# UNITED STATES PATENT AND TRADEMARK OFFICE

09/678,414

<b>Office Action Summary</b>	<b>Application No.</b> 09/678,414	<b>Applicant(s)</b> CARLSON, DAVID W.	
	<b>Examiner</b> Brook Kebede	<b>Art Unit</b> 2823

## DETAILED ACTION

**FIG. 2D**

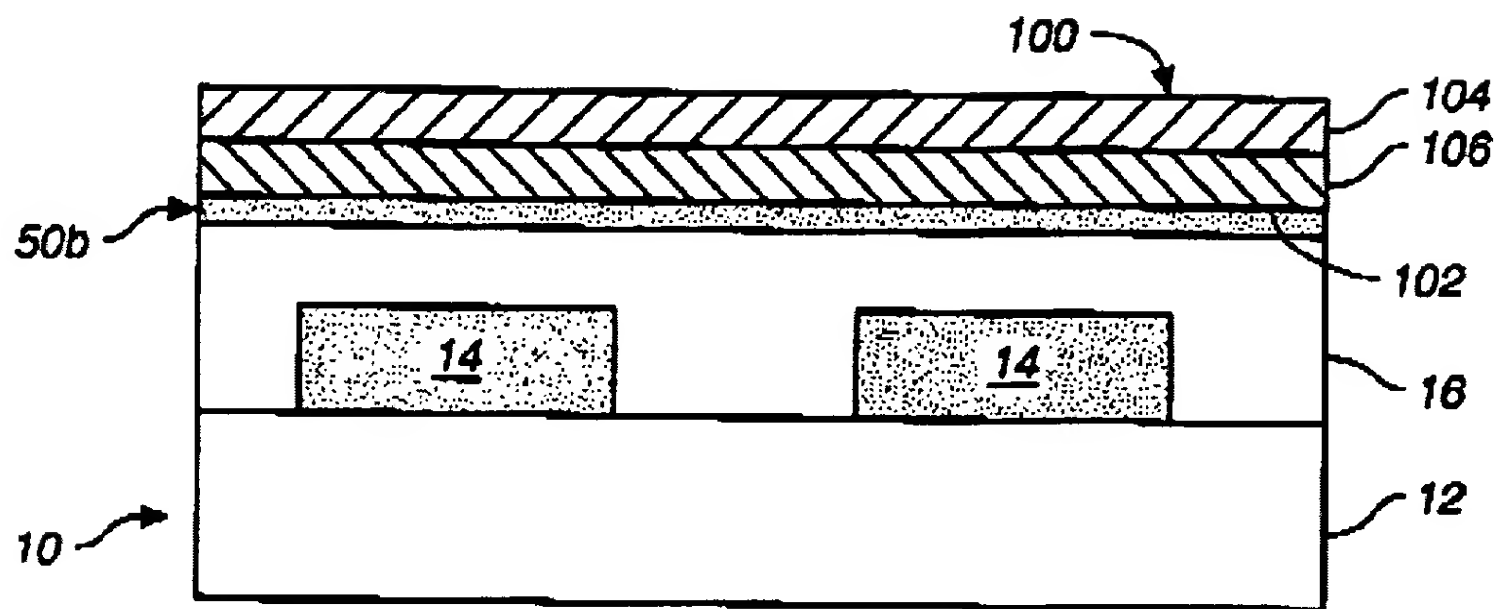
Applicant further argued that "As shown Fig. 2C, Ki teaches that as soon as native oxide layer 18, *the second material*, has been removed, polysilicon 16, the first material, does not have substantially planar top surface as required by claims..."

In response to the applicant's argument, it is respectfully submitted that Li et al. '368 disclose all the claimed limitations the instant application as claimed in claims 31-36, 38-46 and 49-52 as applied above. For example, as shown in Fig. 2D and presented herein below, the first material layer 16 does actually polished to have planar surface prior layer 50b , 106 and 104 are deposited. The removal of the second material layer 18 and planarizing of the second material 16 is happened concurrently within short period of time by CMP process (see also Col. 6, lines 1-5).

**FIG. 2G**

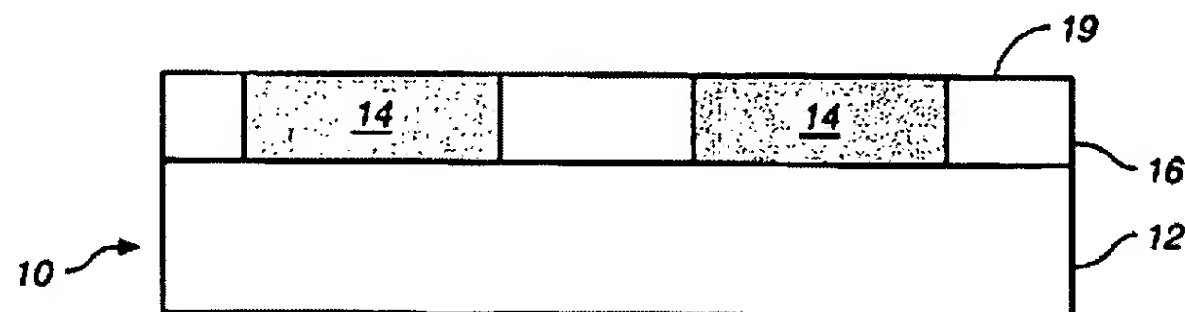
After the CMP process and removal of the material layer 18, the first material layer 16 having a substantially planar surface 19 as shown in Fig. 2G herein below.

Further in response to applicant's contention, it is respectfully submitted the instant application claimed invention does not specifically disclose to the degree of certainty that instant application CMP process will result a perfect planar surface that cannot be achieved by the CMP process of Li et al. '368. There is no evidence can be found in the instant application to the contrary of Li et al. '368 disclosure.

**FIG. 2I**

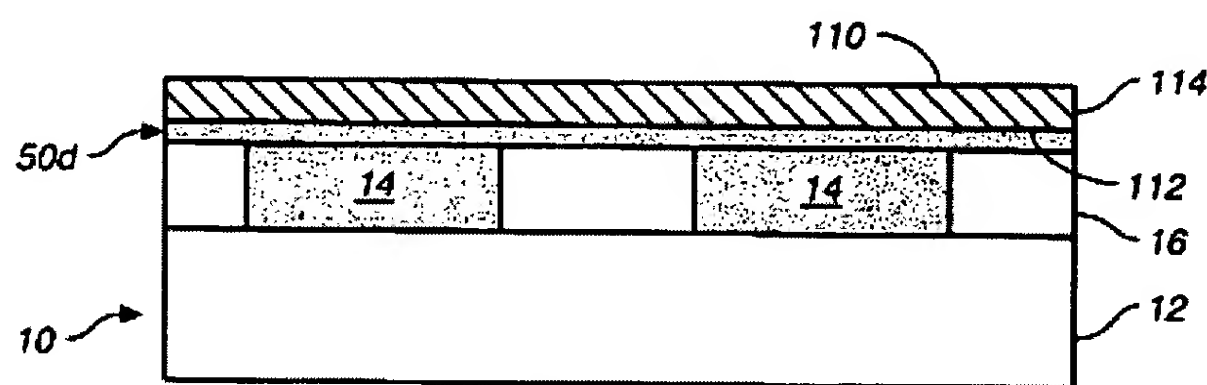
Applicant further argues that "Li fails to teach or suggest formation of third material as claimed ..."

In repose to applicant's argument, it is respectfully submitted that Li et al. '368 disclose all the claimed limitations of the instant application as claimed including forming of third material over the planarized second material 16. For example, Fig. 2I as shown below material layer 114 is meets the claim language third material layer as applied in the rejected claims in Paragraph 4 above.

Further in response to applicants contention that "*Li does not teach or suggest wherein the third layer is a mask layer ...*," it is respectfully submitted that "mask" layer does not have any special meaning as claimed in claims 39 and 50 because applicant does not define what the mask layer entails or represent in terms of it function and usage. Since "mask" has a very broad interpretation and function in the semiconductor industry, the "pad" layer is analogous to "mask" for CMP process. If applicant can provide an evidence the function of "mask" in the instant application different from "pad" in Li et al. the Office would like to see such evidence and such evidence will be valuable in determining of patentability of the instant application. In absence of clear definition to the function and/or meaning of "mask" in the instant application, it is interpreted that Li et al.'s "pad" layer meets the scope and meaning of "mask".
